SUBJECT: COMANCHE PEAK NUCLEAR POWER PLANT, UNITS 3 AND 4  
DOCKET NUMBERS 52-034 AND 52-035  
RESPONSE TO REQUEST FOR ADDITIONAL INFORMATION NO. 5798  
(SECTION 3.7.2)

**RAI NO.: 5798 (CP RAI #221)**

**SRP SECTION: 03.07.02 - Seismic System Analysis**

### QUESTION NO.: 03.07.02-21

Figure 1. Computed ATF for RB Complex PCCV Structure for All Elevations in NS Direction

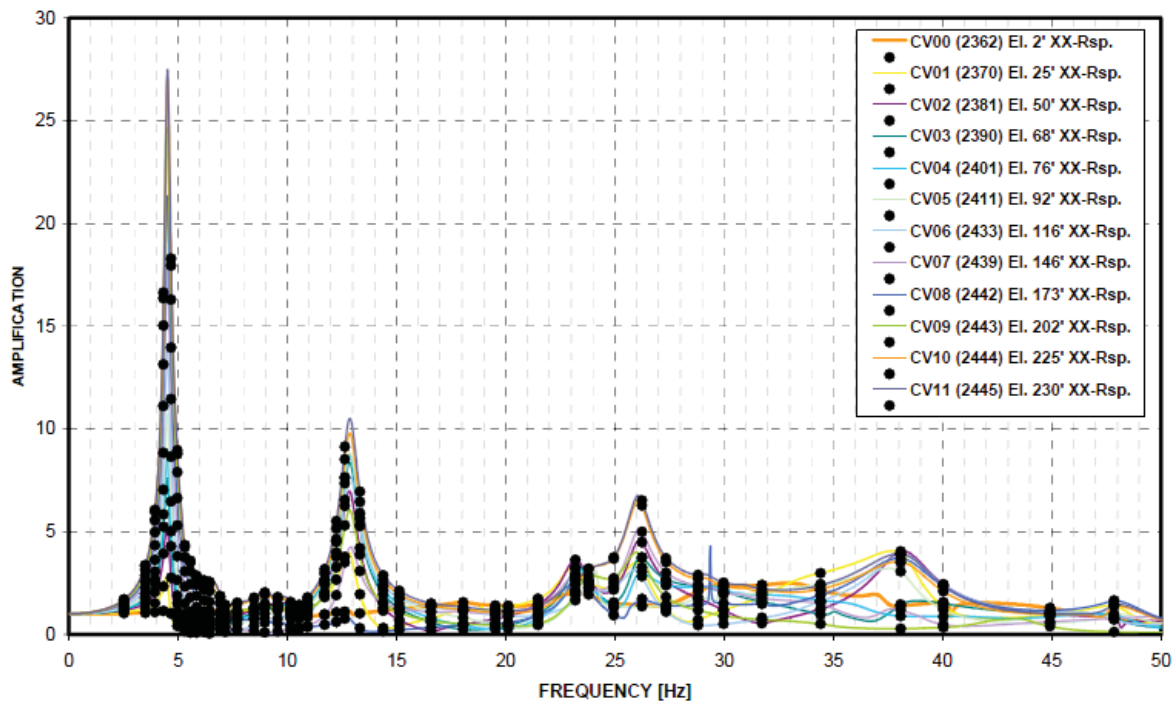
Representative examples are given in Figures 1 through 8 below for the computed ATF for various locations and soil cases for the RB complex, PSFSV, ESWPT and UHSRS. With a few exceptions, all curves are smooth and do not indicate any sharp peaks that could be a Subtraction method numerical instability. For the PSFSV ATF in the Z-direction (Figure 4), a number of sharp peaks, corresponding to data plot points are visible particularly above 40 Hz. Even assuming that these high-frequency peaks are spurious peaks associated with the Subtraction methodology and not associated with interpolation of data, they do not affect the ISRS, which have significant values at much lower frequencies due to the CSDRS-shaped seismic input motion. Another exception occurs for a UHSRS ATF as shown in Figure 8, where a sharp peak occurs at approximately 26 Hz. Due to the narrow bandwidth of the ATF spike and the fact that the ISRS peaks have much larger bandwidth than the ATF peaks, ATF spikes such as the one shown in Figure 8 will have negligible influence on the ISRS, and will result only in increases in ISRS amplitude, which is in the conservative direction.

In conclusion, the review of all ATF plots for the existing Comanche Peak Units 3 and 4 ACS SASSI NQA Version 2.2.1 analyses results indicates that there are no issues related to the ISRS computation due to application of the Subtraction method that could affect the design significantly or in an unconservative manner.
